## REMARKS

Claims 1-22 are pending in which claims 9-22 are allowed and claims 1-8 were objected to in the Ex parte Quayle Office Action.

FIG. 1

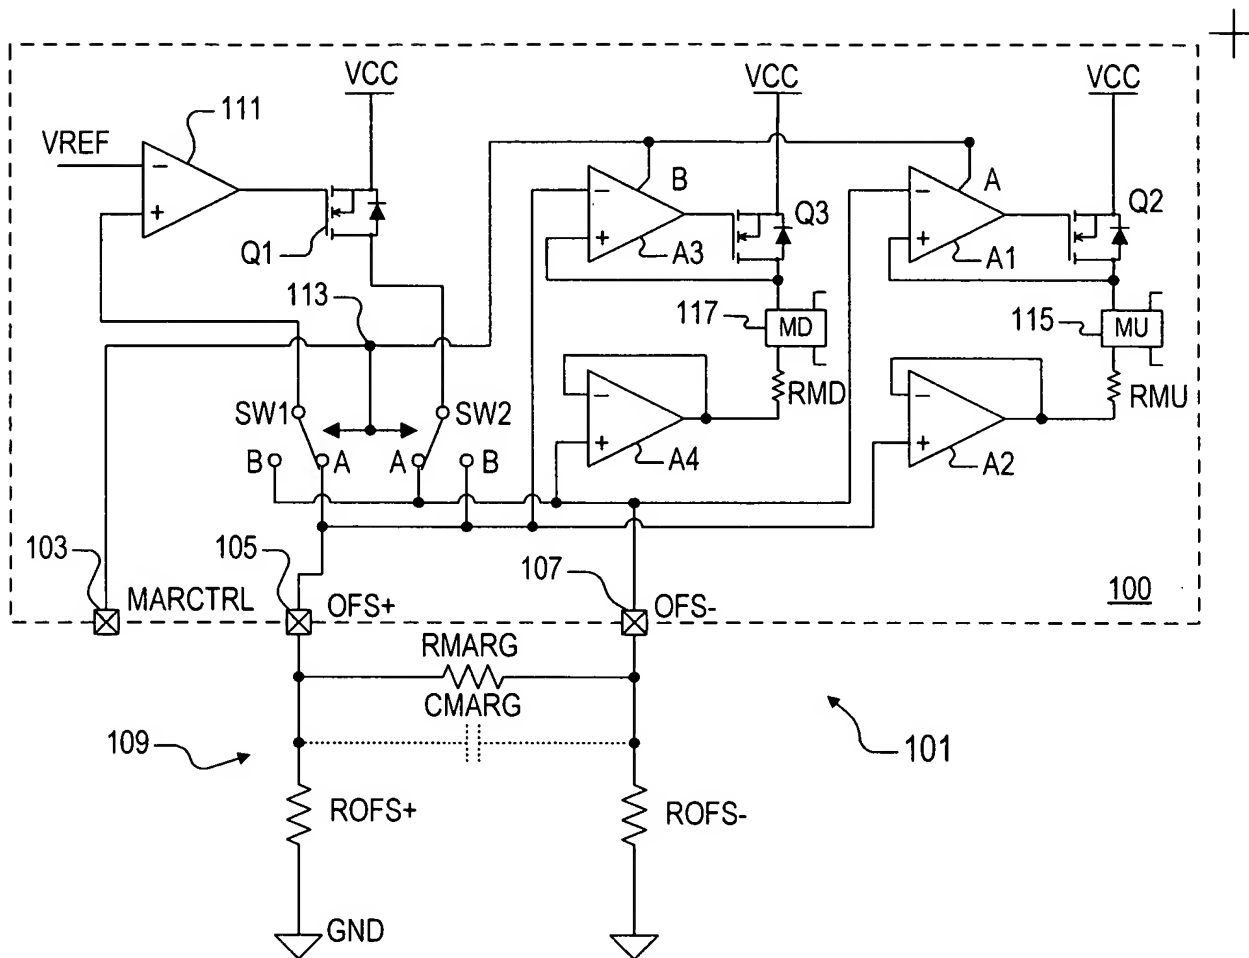
Preliminarily, paragraph [0028] is amended to replace the incorrect reference number 105 with the correct reference number 103 for the MARCTRL pin. As shown in FIG. 1 and as referenced throughout the application as filed, the MARCTRL pin is pin 103 rather than pin 105, which instead refers to the OFS+ pin. Applicant submits that this is a formality error which does not add new matter and requests approval of this amendment.

embodiments shown in the Figures, it is assumed that the reference to modes A and B is in reference to the A and B portions and nodes of FIGS 1 and 2. Thus, as shown in FIG. 1, “mode A” references the MARCTRL pin 103 being pulled high so that switches SW1 and SW2 select the A positions and the amplifiers A1 and A2 are selected, and “mode B” references the MARCTRL pin 103 being pulled low so that switches SW1 and SW2 select the B positions and the amplifiers A3 and A4 are selected. In that particular embodiment illustrated, note that in “mode A” the amplifier 111 drives the OFS- pin 107 to regulate the voltage at the OFS+ pin 105 to VREF, whereas in “mode B” the same amplifier 111 drives the OFS+ pin 105 to regulate the voltage at the OFS- pin 107 to VREF. Continuing this same example, the “first margining resistor” reads on the resistor RMARG and the “first amplifier circuit” reads on the amplifier 111 and supporting circuitry (e.g., transistor Q1). Yet while claim 1 recites that the margining resistor is coupled between “first and second margining nodes”, claim 1 does not specify which node is which. Thus, if the margining nodes read on the OFS+ and OFS- pins, *either one* of these nodes/pins could be the first or the second margining node. Further, the “first offset resistor” reads on *either* resistor ROFS+ or ROFS-, depending on the selected mode, and the “second amplifier circuit” reads on *either* the amplifier pair A1/A2 or A3/A4, depending on the selected mode.

FIG. 2

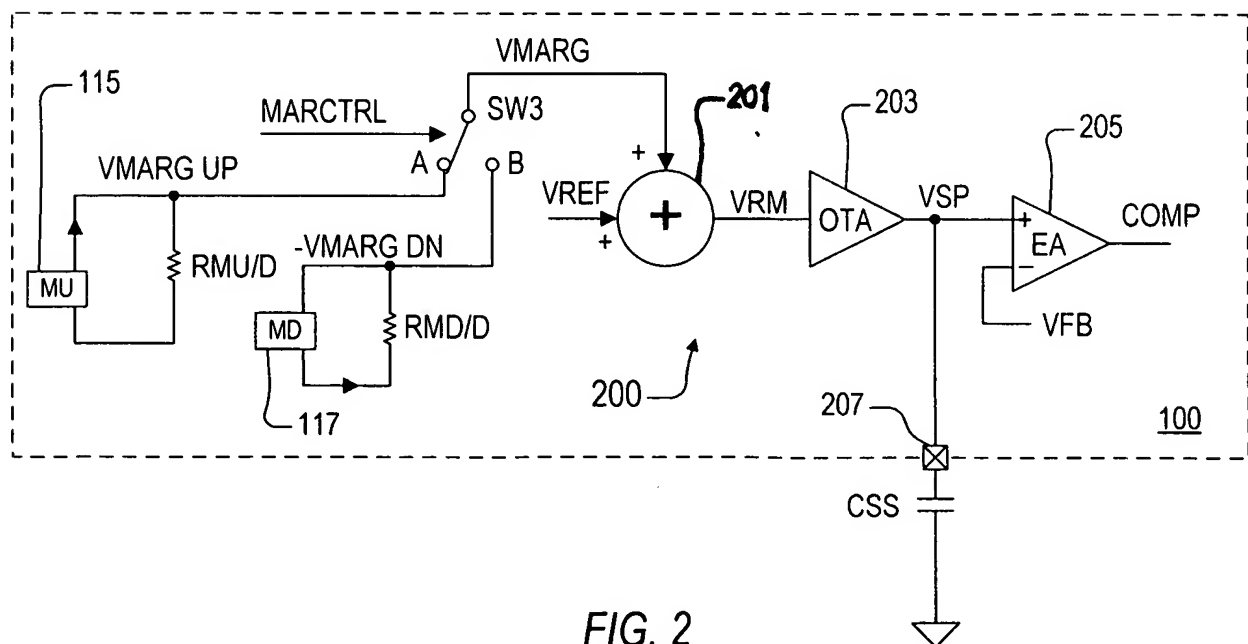
Furthermore, the reference number 201 and leader line identifying the adder 201, which receives and adds the voltages VMARG and VREF and which provides the voltage VRM, are missing in FIG. 2. The adder 201 is initially referenced on the last line of page 14 in paragraph [0028] and again on the top line of page 15 in the same paragraph of the application as filed. Coincidentally, this same paragraph [0028] is repeated and amended herein on page 2 of this amendment. A replacement sheet for FIGS 1 and 2 is included with FIG. 2 including the change in which the missing reference designation 201 and leader line are added to identify the adder 201. An Annotated sheet is also included showing the change in red. Applicant requests approval of this drawing change.

The attached sheet of drawings includes a change to FIG. 2. The replacement sheet, which includes FIGS 1 and 2, replaces the original sheet including FIGS 1 and 2. The annotated sheet shows, in FIG. 2, the change in which the missing reference designation 201 and leader line are added to point to the adder 201. The adder 201 is initially referenced on the last line of page 14 in paragraph [0028] and again on the top line of page 15 in the same paragraph of the application as filed. Coincidentally, this same paragraph [0028] is repeated and amended herein on page 2 of this amendment.
